**STAFF RECOMMENDATION**  
**215 Broadway and 110 3<sup>rd</sup> Avenue South**  
**July 15, 2020**

**Application:** New Construction - Violation  
**District:** Broadway Historic Preservation Zoning Overlay  
**Council District:** 19  
**Base Zoning:** DTC  
**Map and Parcel Number:** 09306404300  
**Applicant:** Broadway Hotel, LLC  
**Project Lead:** Jenny Warren, jenny.warren@nashville.gov

Figure 1: 215 Broadway in March 2020

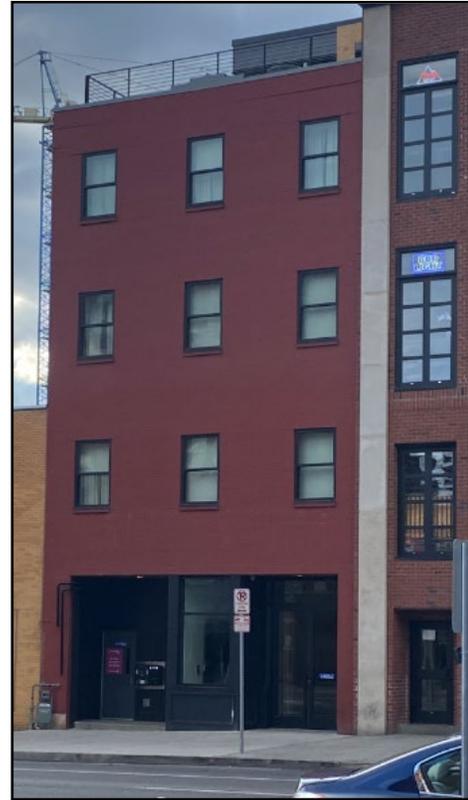
revised on 4/22/2016, after the expansion of the overlays, shows a storefront with a projecting central bay and recessed double doors with transoms on either side (Figures 2 & 3). This was constructed as per the permitted plan on the right side, with full-light doors, and in the central bay. However, the left side was not built out according to the permitted plans (Figure 4). Instead of installing double glass doors with a transom, a solid wall was constructed with two nearly solid doors and no transom. An ATM was also installed here.

Staff finds the current configuration to be inappropriate, as it does not match the permit and does not comply with General Principles, Section II of the design guidelines which state “Replacements of street-level facades should be in keeping with the style and period of the building.”

The lack of transparency on the left side, including the solid transom, the nearly solid doors and the ATM are not typical of a historic primary façade on Broadway.

Staff recommends that the doors and transom be installed into the left side of the storefront, as per the plans approved in 2014, which would also result in removal of the ATM installed without a permit.
